**Technical Service Bulletin**

**Cardio Products**

**Subject:** 20013220A TSB-CP100\_200 LI-ION BATTERY, 2.6 SW

**Product(s) Referenced:** CP100 & CP200 Electrocardiographs  
Li-Ion Battery, 2.6 SW Upgrade Kit P/N: 105204

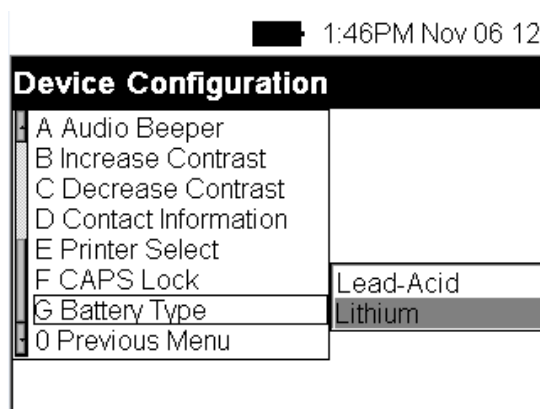
The new Li-Ion battery is a direct replacement part for the existing SLA battery and requires no new tools, parts or accessories to install, only a Phillips head screwdriver to open and secure the battery compartment door to connect the positive battery lead. Replacement instructions are provided in the kit, see: WA material #718845 DFU CUSTOMER LETTER APP V2.6 CP100/200.

Note: A new fuse is provided with the Lithium battery upgrade kit. The old fuse should be replaced and discarded whenever a battery is replaced.

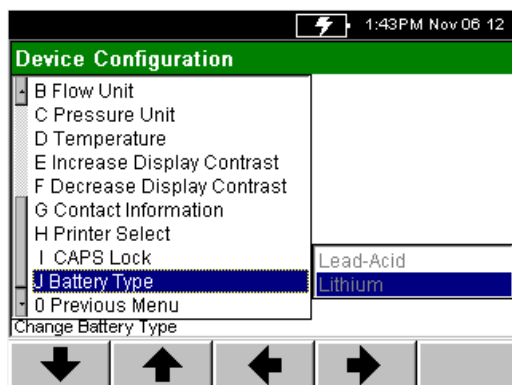
Support for the Li-Ion battery is set by default with the installation of the 2.6 software. If the software is installed into a device that has a Sealed Lead Acid (SLA) battery installed, the battery type will need to be changed manually so that the battery type is correctly selected in the device menu. The software also provides a more accurately displayed battery capacity gauge for the SLA than previous software versions.

- CP-100 Menu:
  1. Press the Menu button
  2. Press “2” for System Settings
  3. Press “1” for Device Configuration
  4. Press “G” for Battery Type
    - NOTE: Example shows software install default choice of Lithium.
